RE: LOUGHMACASK MASTERPLAN

Interim Chief Executive's Report

Submissions received regarding the Draft Loughmacask Masterplan

10th March 2023

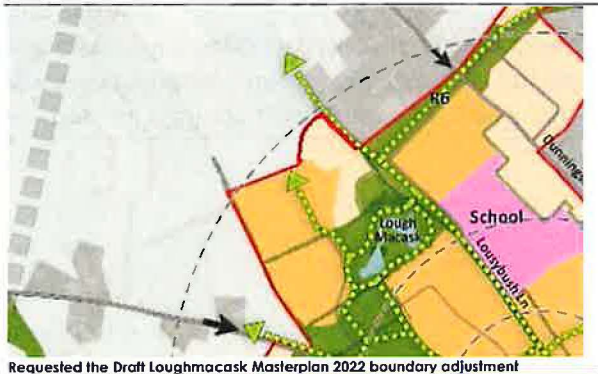
<p>Interim Chief Executives Recommendation:</p> <p>Níl aon athrú molta.</p> <p>No change to Draft Masterplan.</p>
2	Peter Thomson Planning Solutions on behalf of Pat & Mark Cantwell	<p>The submission seeks the adjustment of the Draft Loughmacask Masterplan 2022 boundary as per the map extract below.</p>  <p>This adjustment was recommended by the Interim Chief Executive as a Material Alteration to the Draft Kilkenny County Development Plan 2021-2027 and agreed by the Members in response to a previous submission yet this was not fully reflected in the adopted Plan.</p> <p>A series of maps and an extract from the CE report on submissions to the Proposed Material Alterations of the Draft Kilkenny City and County Development Plan 2021-2027 are included in support of this submission.</p>	<p>Interim Chief Executives Response:</p> <p>The Masterplan area was incorrectly indicated in the draft KCCDP 2021-2027. See relevant extract of draft zoning map illustrated below:</p>  <p>Boundary in Draft City and County Development Plan 2021-2027</p> <p>The Masterplan boundary was subsequently reduced while a portion of lands were also zoned for existing residential purposes. See extract of the amended settlement boundary / zoning map from the adopted KCCDP 2021-2027 illustrated below. The draft Masterplan boundary did not align with adopted Development Plan 2021. The Masterplan will be adjusted to reflect exactly the zoning line in the adopted Kilkenny City and County Development Plan 2021-2027</p>

<p>Zoning and Masterplan boundary as adopted in the City and County Development plan 2021-2027.</p>  <p>Boundary as shown in the draft Masterplan.</p> <p>Interim Chief Executives Recommendation:</p> <p>It is proposed to amend the Masterplan boundary to reflect the zoning boundary as indicated in Figure CS4 of the Kilkenny City and County Development Plan 2021-2027.</p>
3	Environmental Protection Agency (EPA).	<p>A copy of '<i>SEA of Local Authority Land Use Plans – EPA Recommendations and Resources</i>' is included with the submission. It is suggested that this guidance document is taken into account.</p> <p><u>Content of the Environmental Report</u></p>	<p>Interim Chief Executive's Response:</p> <p>The SEA Environmental Report includes references to various EPA guidance, recommendations, and resources.</p> <p>Section 10 of the Environmental Report sets out the approach to monitoring of the implementation of the plan.</p>

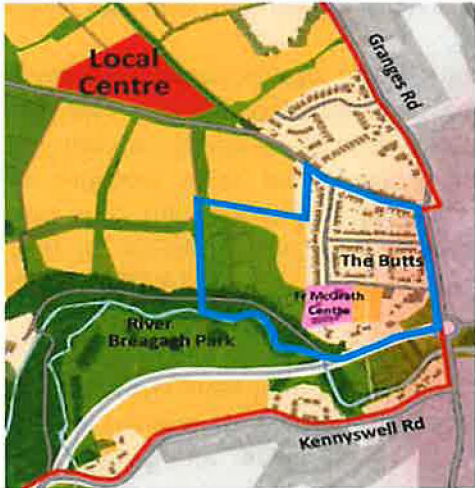
<ul style="list-style-type: none"> - The increase in traffic volume into the area will exacerbate an already critical level of traffic. - The Masterplan has no regard for the wellbeing, mental health, or safety of residents and does not serve the people. <p>It is clear nobody has stood on the Granges or Freshford Roads at 8:30 on any given weekday. The new and planned developments are not sustainable with the current road infrastructure and it is responsibility of the senior planner to resolve concerns raised by residents to ensure the plan delivers a safe uncongested community.</p>	
12	Armstrong Planning on behalf of Shay Properties Ltd	<p>Shay Properties are the new owner of Kilcreene Lodge which is a fully restored protected structure set within the River Breagagh Valley. The property constitutes important historic fabric that is integral to the cultural history of Kilkenny. As the new owners acquired the site in 2021, they were not in a position to participate in earlier consultations (i.e. January 2020) and this is their first opportunity to do so.</p> <p>The previous owners were successful in securing planning permission (planning ref: 21/280 & 21/400) for 9 large family homes on the grounds and the houses were never built out. It should be noted that the new owner is not inclined to develop this historic site. It is their intention to conserve and protect this important component of Kilkenny's built heritage instead. These ambitions very much serve the National Strategic Outcomes of the National Policy Framework (NPF) as they aim to ensure 'enhanced amenity and heritage'.</p> <p>The Council is asked to have regard to a range of issues outlined under the following four headings which include Heritage Value, Transport Infrastructure, Aspirational Pedestrian / Cycle Routes and Ecology.</p> <p><u>Heritage Value</u> It is submitted that the Draft Masterplan:</p>	<p>Interim Chief Executives Response:</p> <p>The Council acknowledges the wishes of the landowners to keep lands free of development, notwithstanding the extant permissions.</p> <p>In relation to the other matters raised these are addressed under the headings below:</p> <p><u>Heritage Value</u> It must be recognized that Kilcreene Lodge is a protected structure (B117) as part of the City & County Development Plan. It is supported and guided by the built heritage policies associated with the RPS. It is considered that the Masterplan respects the heritage value of the lodge and its setting, which is reflected in its land use designation as an area to be used for amenity.</p> <p>Connections were indicated through the lands to showcase the lodge and its setting whilst also providing a recreational area for the community.</p> <p>In relation to section 5.1.1. the intention of the wording is to enhance existing heritage and green characteristics in the area. It will be proposed to amend this wording to provide clarity.</p>

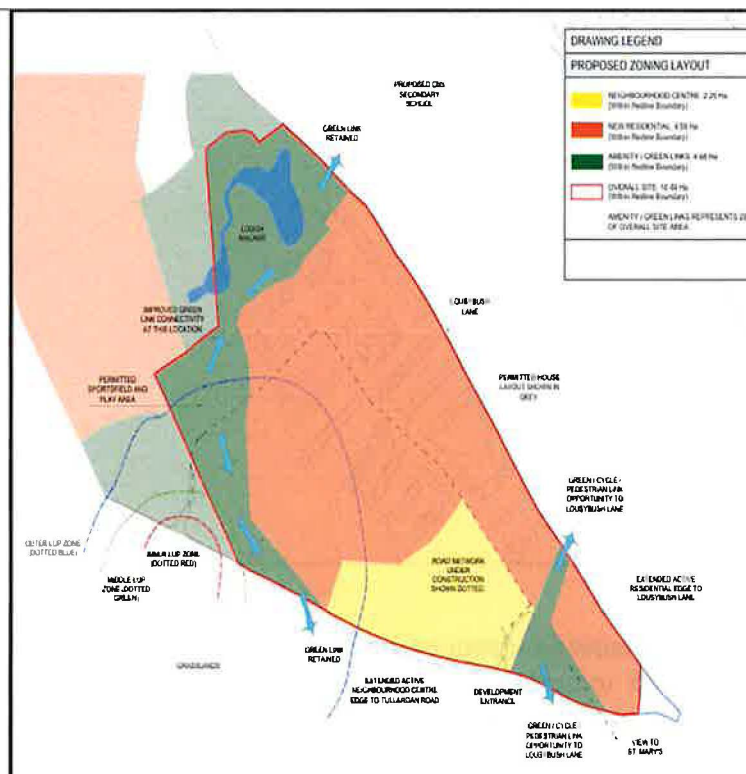
<p>safely and minimising traffic disruption. Cycle lanes also need to be provided.</p> <p><u>Road Infrastructure/Traffic</u></p> <ul style="list-style-type: none"> - There will be significant noise from vehicles entering and leaving the roundabout from the Dunningstown Rd to the CBS. - HGVs should be banned from school access road (from Freshford and Dunningstown Roads to the school). - Priority should be given to completing the outer ring road. This will ensure traffic to and from Grasslands to bypass the city. This would reduce inappropriate traffic volumes around the schools and in busy residential areas. 	<p>congestion in the area including R6 extension to the Tullaroan Road, Objective R7 and the Northern Ring Road extension from the Freshford Road to the Castlecomer Road.</p> <p>Interim Chief Executives Recommendation:</p> <p>No change. Also see response to submission 6.</p>
18	Mike Donohoe	<p>The Council is thanked for presentations on the Masterplan and for issuing a summary to each household. However, there are some concerns in relation to traffic and road infrastructure. These are outlined below:</p> <ul style="list-style-type: none"> - There is a lack of joined up thinking between the Central Access Scheme, the Outer Ring Road and the Masterplan. - Originally Lousybush Lane was to be upgraded for all traffic types, providing part of the Central Access Scheme, Phase 3. The plan seems to have scrapped that in favour of a cycle/pedestrian only route. Its sole function is now to provide access to the new CBS and a cluster of houses at the end of the lane. - The high volume of traffic on Granges Road and Freshford Road is referred to especially at school drop-off / pick-up times. This is exacerbated by the expansion of St. Luke's Hospital and heavy trucks from PRL, Glanbia and others. - Scrapping phase 3 route via Lousybush Lane removes a proposed route from Freshford Road to the Western Environs providing no alternative to access other areas without transiting through the city centre. 	<p>Interim Chief Executives Response:</p> <p>Objective R5/ phase 3 of Central access Scheme in the 2014-2020 City and Environs Plan was to connect from Lousybush lane to the new Breaghagh Valley. This link was removed in the 2021-2027 City and County Development Plan. To remove through traffic from the Loughmacask area this objective was replaced by objective R7, which aims to connect the Freshford Road to the Kilmanagh Road via an inner orbital route and which is a priority for the Council. Also see response no. 6 above.</p> <p>It is also now proposed to investigate how R6 can be best connected to the Tullaroan road.</p> <p>Lousybush Lane will at least in part function as an active travel route which could at a later stage accommodate public transport, subject to review in the Sustainable Urban Transport Plan (KSUMP).</p> <p>Interim Chief Executives Recommendation:</p> <p>See recommendation to submission no. 6.</p>
